**TOWN OF KESTREL FALLS – DEVELOPMENT SERVICES DEPARTMENT
SITE DEVELOPMENT PERMIT – MASTER COMMENT REPORT**

CASE NUMBER:	SDP-2026-0188C	UPDATE:	U1
REVISION #:	01	PHONE #:	(555) 741-3300
CASE MANAGER:	Priya Raman	EMAIL:	p.raman@kestrelfallstx.gov
PROJECT NAME:	Ridgeline Commons – Phase II		
LOCATION:	4420 QUARRY BEND PKWY (Tract 3, Kestrel Falls Business Park)		
SUBMITTAL DATE:	May 26, 2026		
REPORT DUE DATE:	June 24, 2026		
FINAL REPORT DATE:	July 2, 2026		
	6 DAYS HAVE BEEN ADDED TO THE UPDATE DEADLINE

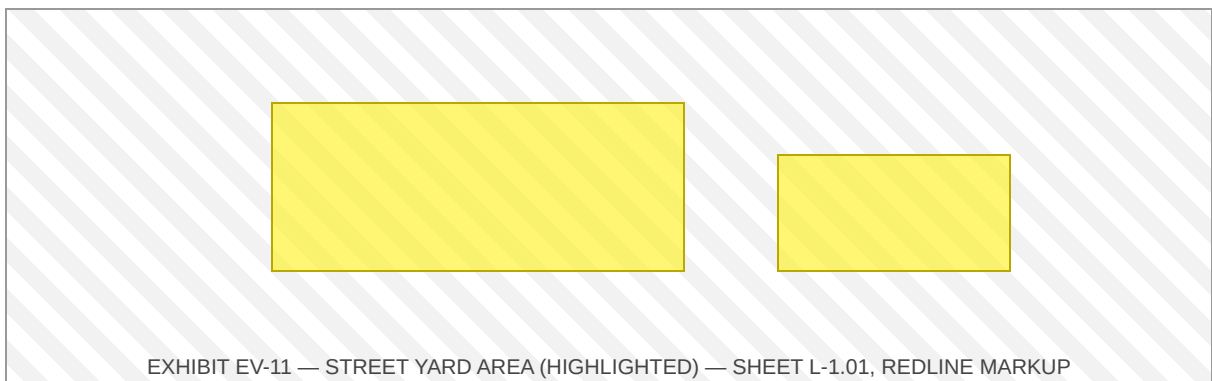
- EV 11 Revise the graphic delineation of the street yard area on the Landscape Plan, as shown in the below image. [LDC Section 25-2-1003, ECM 2.4.1]
